Downtown Development Review Overlay (DDRO) District

MEMORANDUM

Case No: 22-OVERLAY-0028

Property Address: 133 W. Market St.

Currently Proposed Design – Main Corner of 2nd & Market

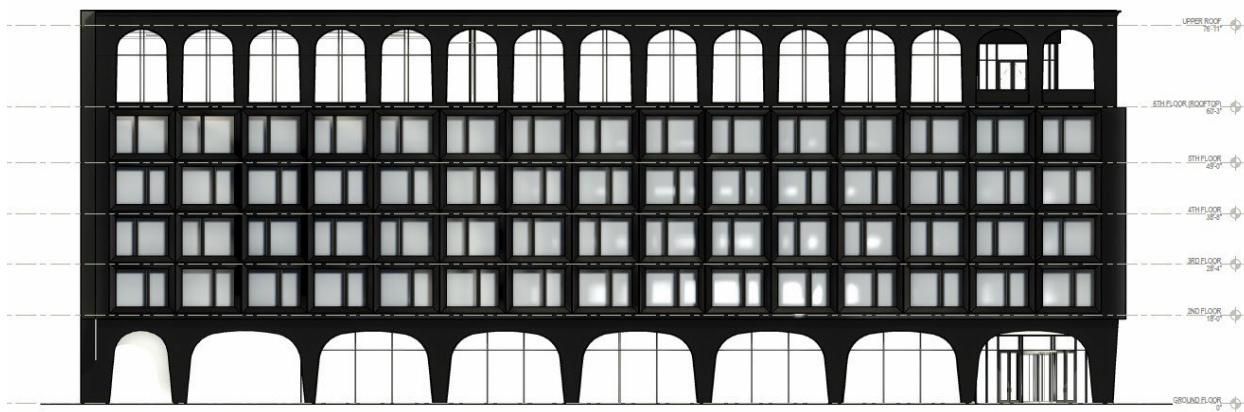
However, there has been a loss of definition for the main corner of the building and defined articulation at the pedestrian street level, that was more discernible in the approved design. The approved design provided visual weight at the corner, through a change in height, slight wall projection, and change in material. This added emphasis and weight clearly identified the main entrance and provided a better spatial relationship with the Convention Center across the intersection. From several vantages, it also helped to break up the overall massing and flat planes of the upper stories.

With the proposed design, the corner is no longer easily discernible from the rest of the building. The height is now uniform across both street-side facades and there is no significant material change. The repetitive arches along the top and bottom continue along the full lengths of each street-side façade, which removes some of the articulation provided by the previously angled walls. While the previously proposed angle visually breaks up the massing and more strongly establishes the corner entrance, the arches at the top and bottom of the building improve the pedestrian experience and result in the building being more dynamic and interesting with varying window forms. The upper arches are slightly stepped back which helps break up the massing along the horizontal. Ultimately, the introduction of the arched openings provides more architectural deviation and makes the building more unique from other buildings downtown. However their

placement along the entire lengths of the façade minimalizes the important corner and establishes a more uniform height. If the changes are approved, attention should be paid to highlighting the corner through other non-architectural means, such as signage, lighting, and/or public art. Entrances should be emphasized with lighting and doorway/storefront features that are distinct from other areas along the ground level. If specific treatments are given in the finishing details, the massing could be better broken up and the corner/main entrance given more emphasis:

1. A projecting sign installed above the main corner entrance, placed at an angle to be easily seen from both 2nd and Market Streets. Sign design that incorporates neon or marquee style bulbs lighting individual letters or surrounding the cabinet would be particularly encouraged for added dynamism for the district at a busy intersection (refer to photo below, which is for example purposes only).

2. Finish the inner sides of the arches by the entryways to stand out from the other arches along the base. This could be through paint different material application, such as a paint color or metallic finish treatment.
3. Finish the paving areas within the main entrance alcoves to be different and visually impactful from the surrounding sidewalk.
4. Install special lighting features in the arches or ceilings of the entry alcoves to be different and visually impactful from the other, storefront only archways, such as up lighting, different colors, or lit/hanging ceiling features.

8. **Prior to occupancy, finalized design details and materials shall be submitted to Planning and Design Services staff for final review and approval to address the issues with corner of the building and street-facing entrances as described in this report**

Currently Proposed West Façade – 2nd St.

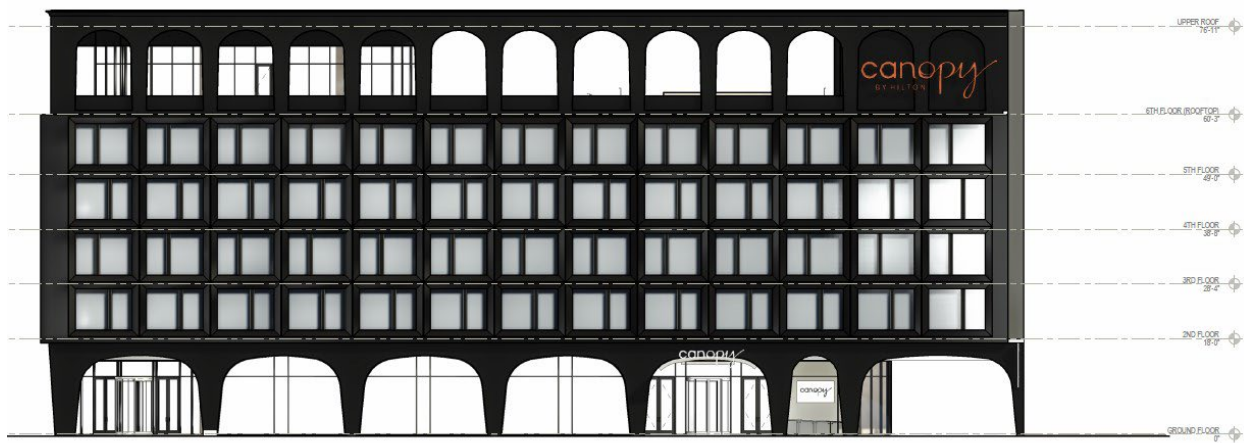
The general massing and height of the building remains relatively the same. The proposed changes introduce a greater amount of storefront glass at the pedestrian level along 2nd and Market Streets. The number of upper story window openings are generally the same, as well as their sizes and proportions; however the top story openings have been modified with arch tops.

At this time, the applicant has not provided a full solution to address the non-descript portions of the north and east facing walls. The Committee requested that the applicant refine the design by addressing the blank areas within the façades with public art and/or

additional further architectural detailing. The applicant has improved these facades in the new design; however they continue to lack significant architectural detail or interest. The north-facing façade will be prominent and highly visible. The condition of approval requires the applicant to address this issue by building permit issuance, and the applicant is significantly closer to this point than before when the Committee previously reviewed. Any additional Committee direction or ideas on how to address this issue can be provided at the meeting.

4. **The applicant shall refine the design by addressing the blank area of the northern and eastern façades with public art and/or additional further architectural detailing. Prior to the issuance of a building permit for the new building, plans for public art and/or further architectural detailing for the north most façade shall be submitted to Planning and Design Services staff for review and approval.**
